#### Index of Records Urban Residential Development Regulations Ordinance 25-057 (ECAF 2025-3126) Hearing Date: Wednesday, December 3, 2025 @ 10:30 a.m. PDS Staff: Hilary McGowan **Council Staff: Ryan Hembree DPA: Alethea Hart** Click on exhibit number to view document # OF RECORD **EXHIBIT EXHIBIT DESCRIPTION** DATE RECEIVED FROM PAGES **TYPE** 2.0 Planning Commission Briefing to Planning 02/05/25 Hilary McGowan, PDS Staff Commission: Proposed Code 2.0003 Staff Report 16 **Amendments URDS** Planning Commission 2.0012 06/09/25 Planning Commission Letter 2 Recommendation 3.1 ECAF and Materials Transmitting Executive initiated **ECAF** 09/29/25 3.1.001 Executive/PDS 2 Ordinance 3.1.002 09/29/25 Introduced Ordinance 37 Ordinance Executive/PDS Councilmember 09/29/25 3.1.003 Introduction Introduction Slip 1 Nate Nehring 3.2 Council Planning Committee Materials Ryan Hembree, 10/21/25 3.2.001 Staff Report Council Staff Report 1 Council Staff Link to Video of Planning 3.2.002 Video 10/21/25 Council Staff 1 Committee Meeting 3.2.002a Agenda 10/21/25 Council Staff Planning Committee Agenda 3 Planning Committee Minutes 3.2.002b Minutes 10/21/25 Council Staff 4 3.3 Correspondence, Comments, Te

Figure 30.23.040(59). ((Example of relationship)) Relationship of ((building height)) Building Height to ((stepback)) Setback

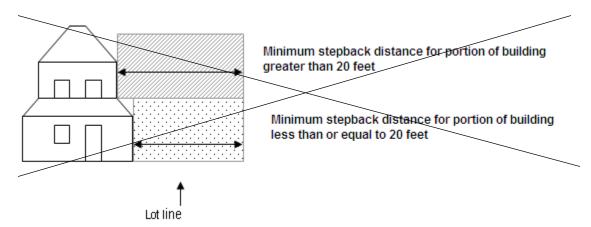
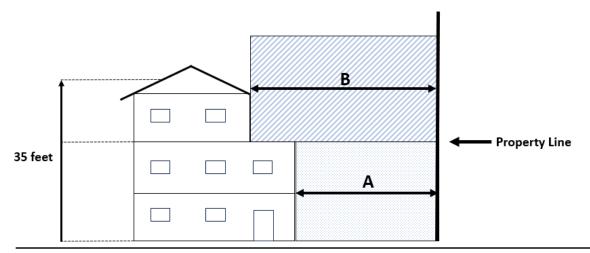
This proposed change to setbacks clarifies setbacks to reflect the proposed new diagram in SCC 30.23.040 and the interpretation of setback.

- (a) Set the entire building back the minimum setback distance; or
- 5 6
- (b) ((Stepback)) Setback those portions of the building exceeding 20 feet in height to the minimum setback distance, as illustrated in Figure 30.23.040(59).

"A" represents the minimum setback distance for the portion of a building less than or equal to 20 feet in height.

"B" Represents the minimum setback distance for the portion of a building greater than 20 feet in height.
